DEPARTMENT	REVIEWER	DATE OF REVIEW	STATUS OF PROJECT	
PLANNING	Bethany Ross	07/21/2022	Approved w/ Comments

07/21/2022: SP2022-041; Site Plan for Helping Hands

- I.1 This is a request by Jeff Carroll of Carroll Architects, Inc. on behalf of Jon Bailey of Helping Hands for the approval of a Site Plan for a Commercial Building on a 8.869-acre tract of land identified Lot 1, Block A, Waggoner Gardens Inc. Addition, City of Rockwall, Rockwall County, Texas, zoned Commercial (C) District, addressed as 950 Williams Street.

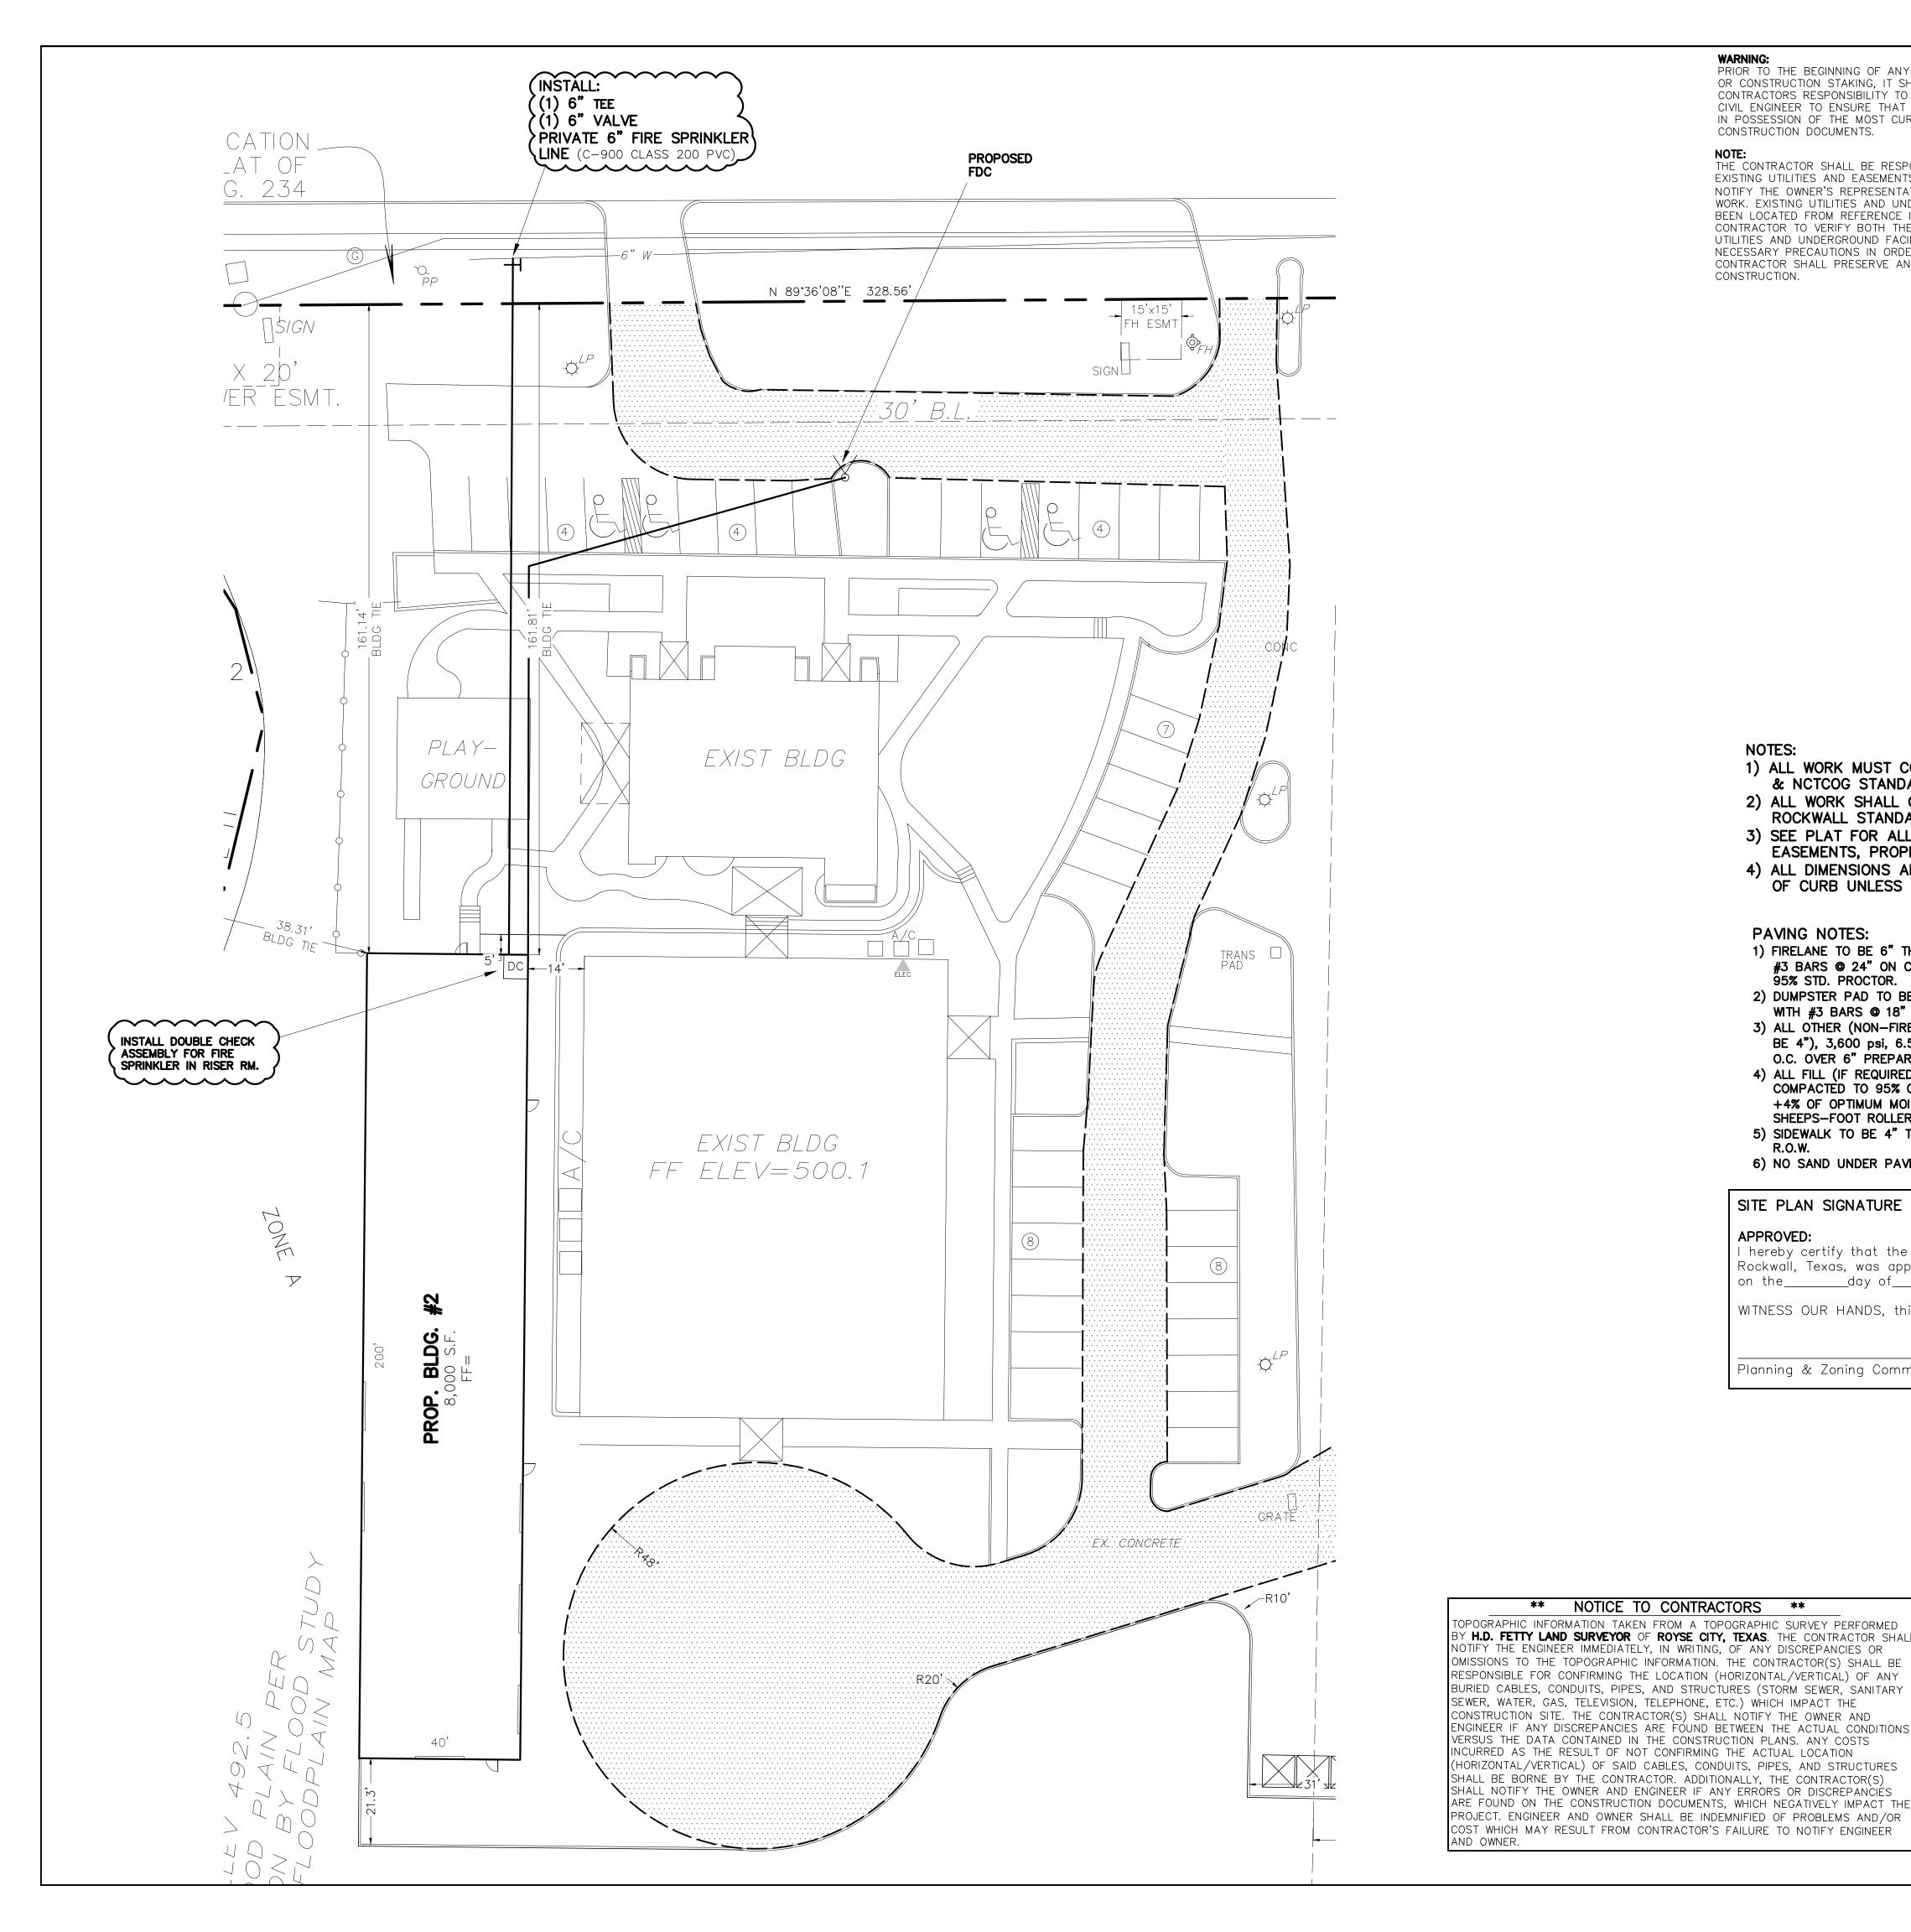
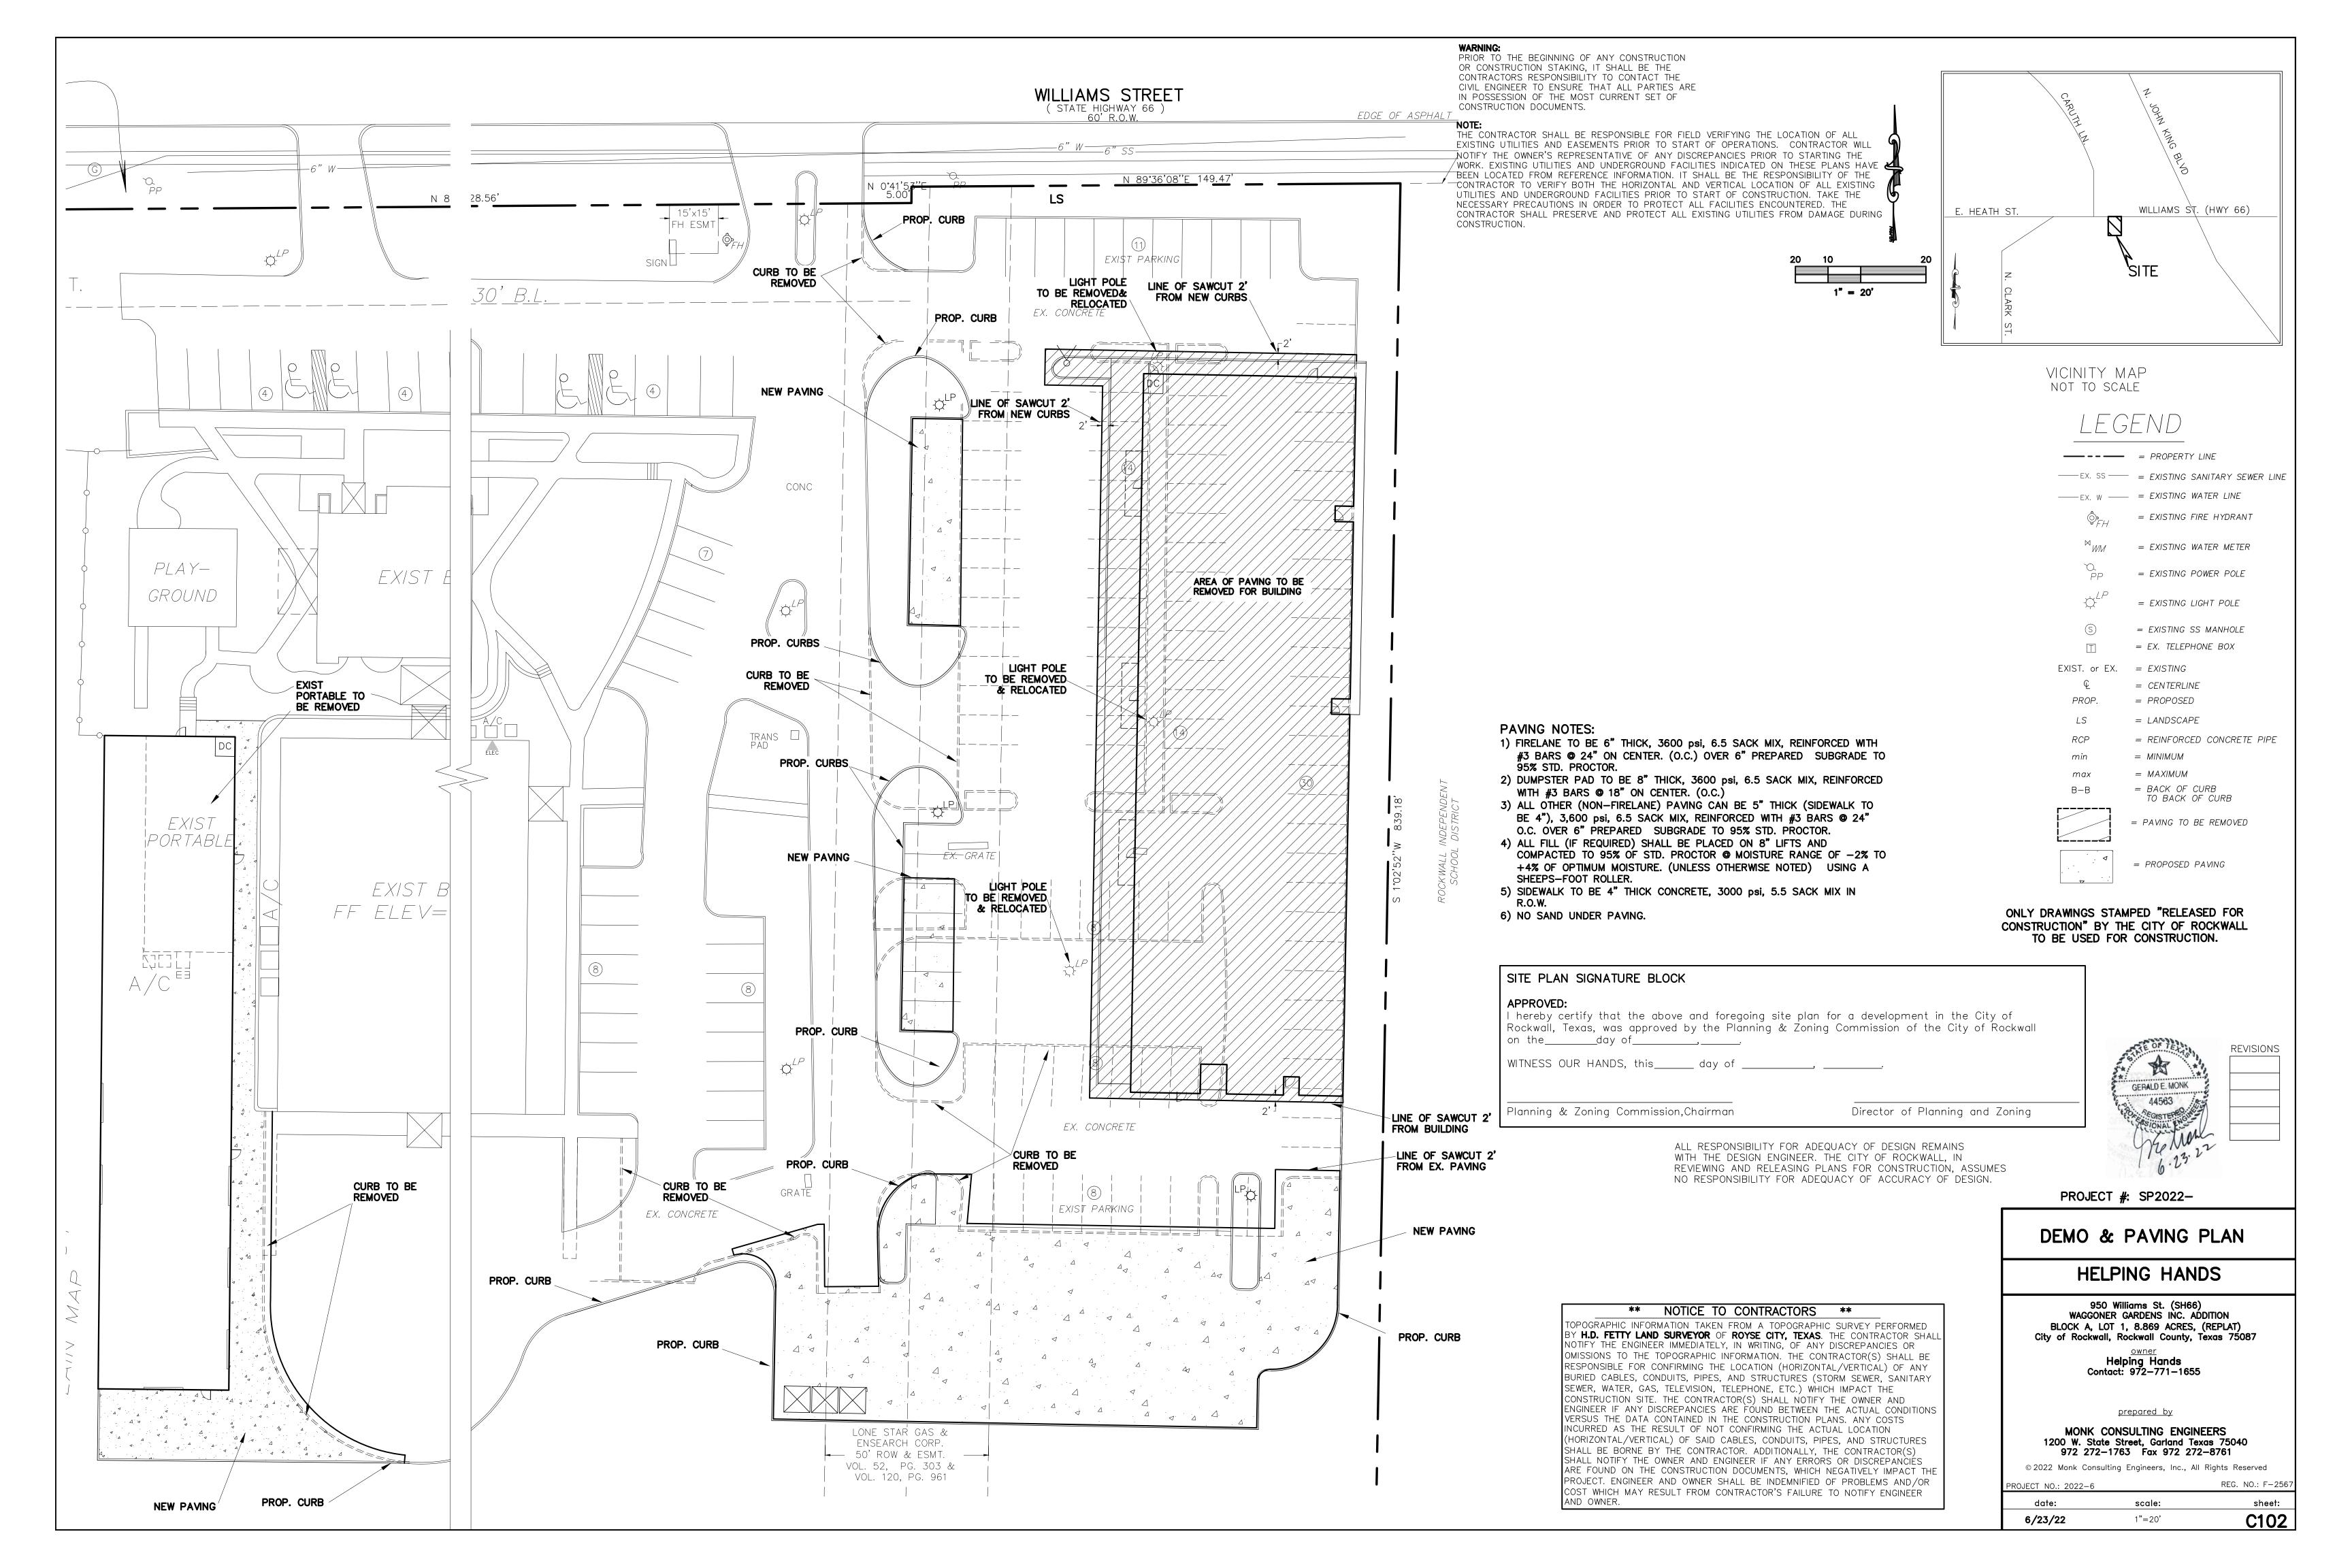
- M.4 Please remove the word replat out of the title block.
- 1.5 The subject property will be required to be replatted after the engineering process to establish the new easements.

- M.6 Site Plan
- (1) Indicate the perimeter dimensions of the site. (Subsection 03.04. B, of Article 11)
- (2) Provide a table including the existing SF of the site vs. the proposed SF on site.

- (9) Are there any roof mounted or pad mounted utility equipment? If so, indicate them on the site plan and building elevations and show any subsequent required screening (e.g. screening with taller parapets or adding louver screening). (Subsection 01.05. C, of Article 05)

- (10) Dumpster Screening. The masonry screening wall must be 12-feet by 10-feet, and 8-feet in height because the property is located in an overlay district. The gate must be self-latching and not manual. The dumpster enclosure must be faced in the same material as the primary building. The enclosure must have 5-gallon shrubs planted around it. Please provide a detail. (Subsection 01.05. B, of Article 05)
- (11) All head-in parking shall be 9' X 20'. (Subsection 2.20.3(a), City of Rockwall Standards of Design and Construction)
- (12) Indicate any outside storage if applicable and provide subsequent screening. (Subsection 01.05E, Article 05, UDC)

**EXTERIOR ELEVATIONS**

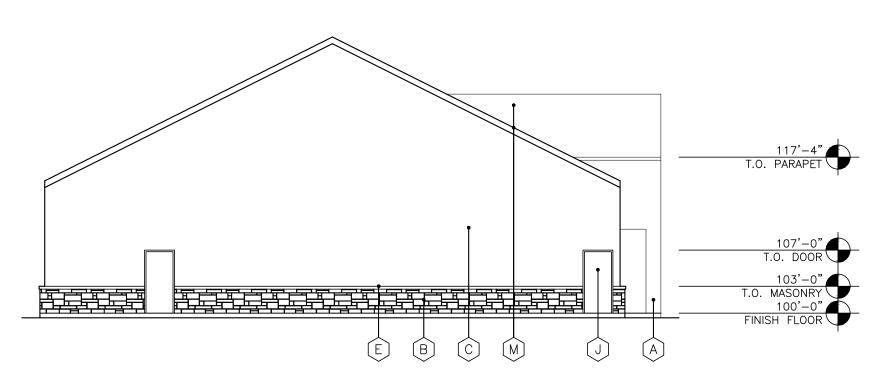
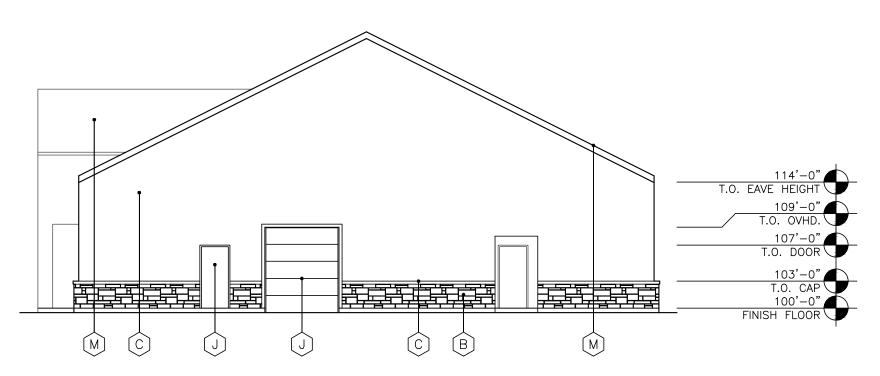
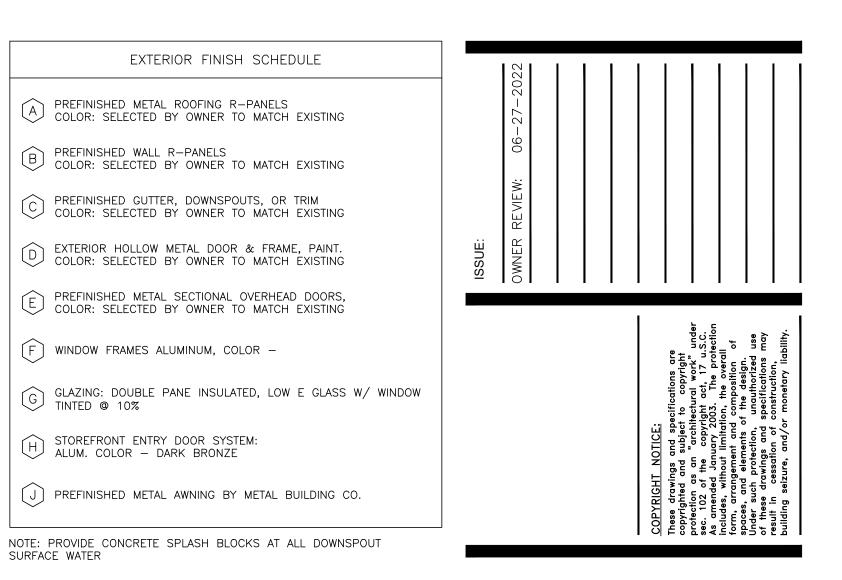
- (1) Provide elevations for both proposed buildings.
- (2) Please label the horizontal measurements for all elevations.
- (3) Label each exterior elevation and indicate which elevations are adjacent to Public Right-of-Way.

- (5) Provide all specifications and descriptions of each proposed building materials and please provide a physical material sample board that meets the City's submittal requirements. (Subsection 04.01 of Article 5)
